Re: Emery Deep Mine Permit C/015/015  
Amendment to add Zero Zero North LBA (UTU-86038) to MRP deficiency response, task id 3405

## Deficiency List

Add Zero Zero North LBA (UTU-86038)

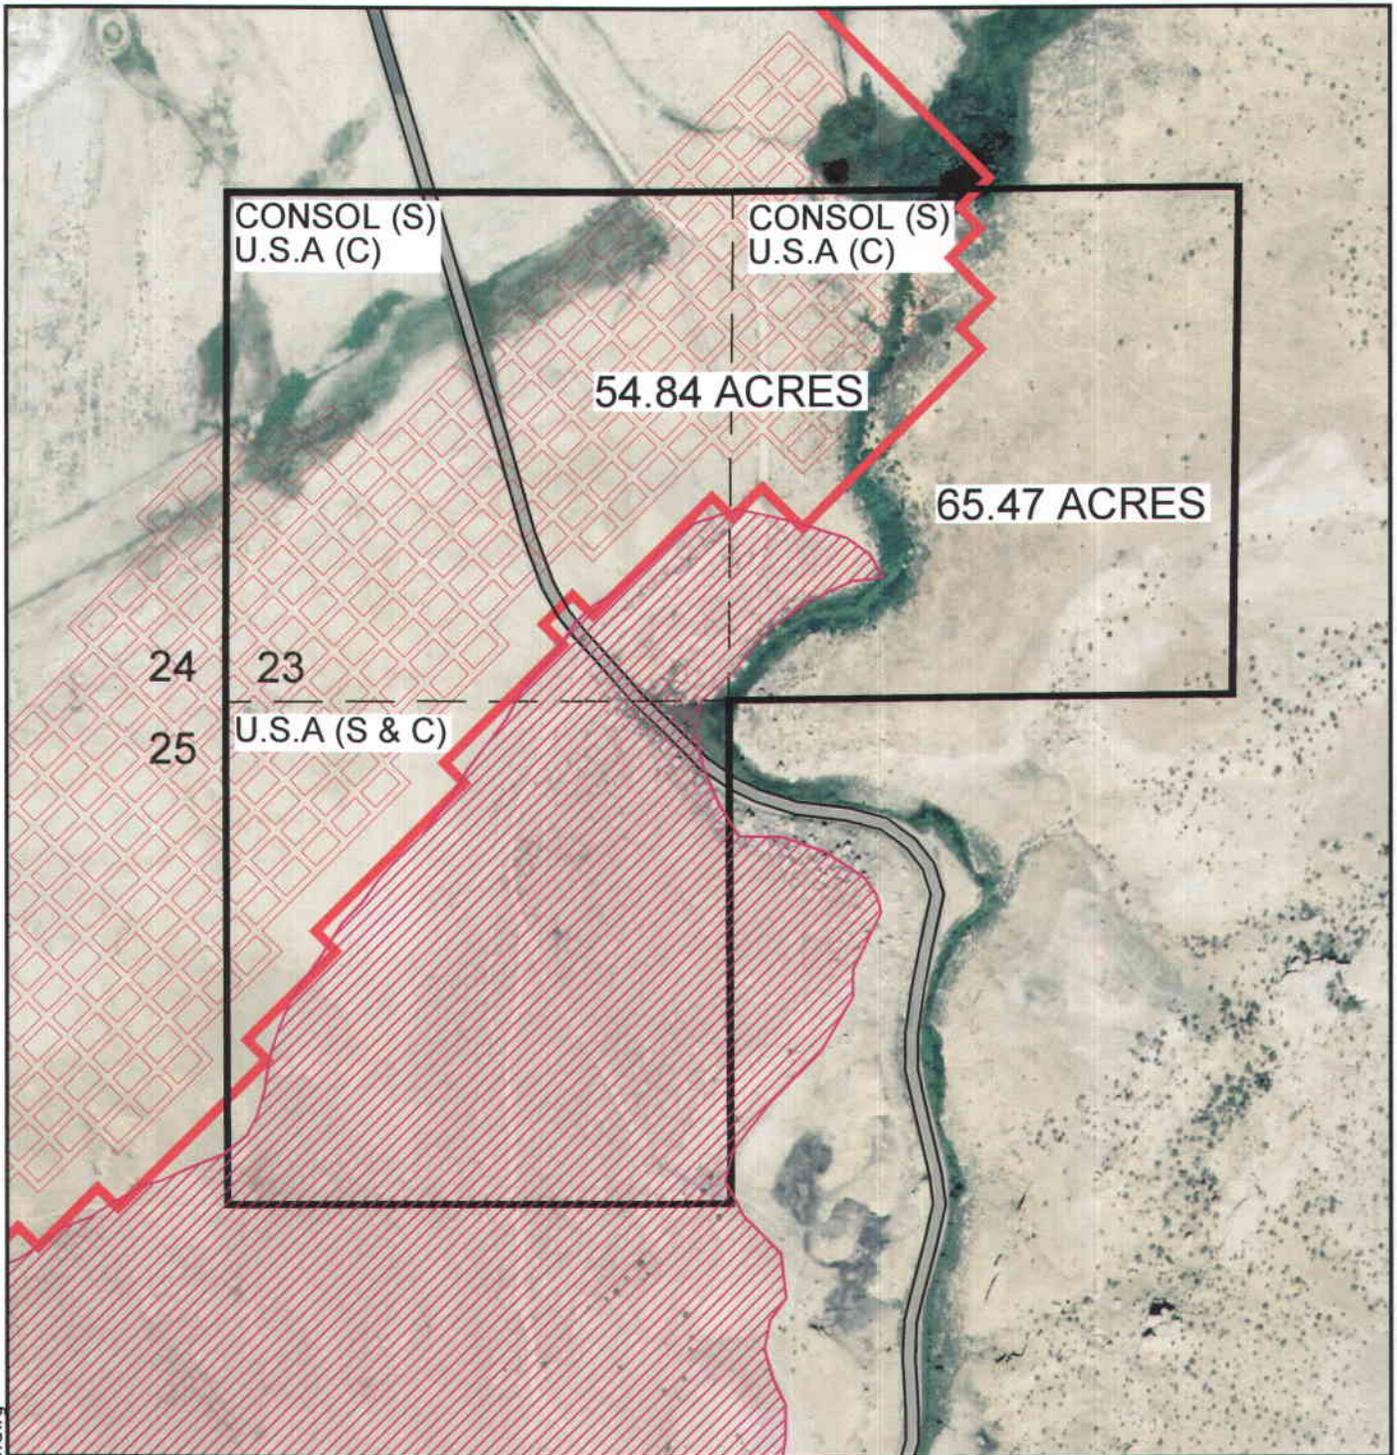
**R645-301-120:** The Permittee should provide additional figures within Appendix VI-16, *Selected Text from Miller Canyon Tract EA*. The baseline information contained within Appendix VI-16 cites Figures 3 and 4 from the Environmental Assessment. For clarification, Figures 3 and 4 should be included with the information submitted in Appendix VI-16. (SC)

*Figure 3(Site Map) and Figure 4 (Water Resources) from the Miller Canyon Tract Environmental Assessment have been included in Appendix VI-16*
